SB-10056697-7185

2013-2014 C-MAX

This article supersedes TSB 13-7-10 to update the model years, Title, Issue Statement and Service Procedure.

Technical Service Bulletin Title: 2013-2014 C-MAX – Discharged 12 Volt Battery

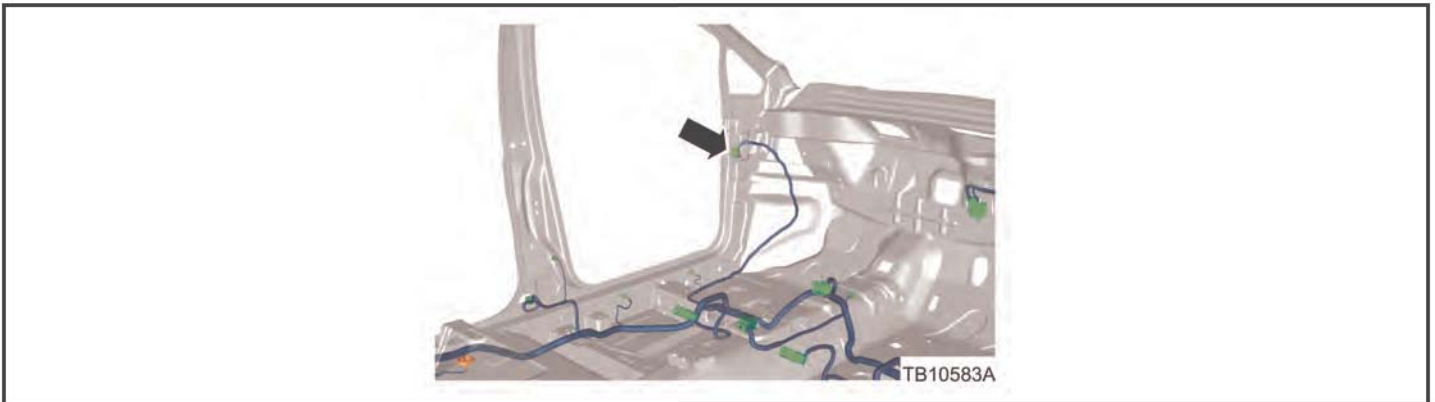
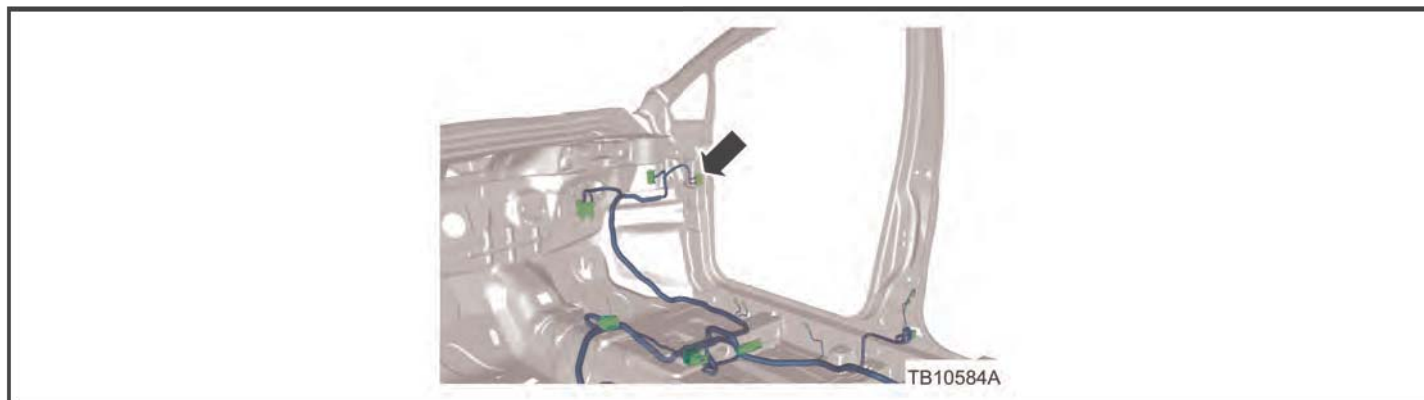
- a. Yes - replace telematics control unit (TCU) Module. Refer to WSM, Section 415-00. Proceed to Step 6.
 - b. No - proceed to Step 6.
6. Is the vehicle built on or before 6/3/2013?
- a. Yes - proceed to Step 7.
 - b. No - proceed to Step 8.
7. Inspect wiring for damage or chafing in rear liftgate area, driver door connector wire harness C339, and front passenger door connector wire harness C340 (Figures 1, 2, 3 and 4). Is damage or chafing present?

- a. Yes - repair circuits as needed. Refer to Wiring Diagram (WD), Section 5-1. After repair, wrap affected area with 3M™ Temflex™ Cotton Friction Tape or equivalent to prevent future concerns. Proceed to step 8.
 - b. No - wrap affected area with 3M™ Temflex™ Cotton Friction Tape or equivalent to prevent future concerns. Proceed to step 8.
8. Print information sheet and provide to customer. Communicate to customer that Ford recommends disconnecting any devices attached to the auxiliary power port, USB port and OBDII port when the vehicle is turned off (e.g. cell phone chargers, USB devices, insurance company snapshot devices, etc.). (Figure 5)
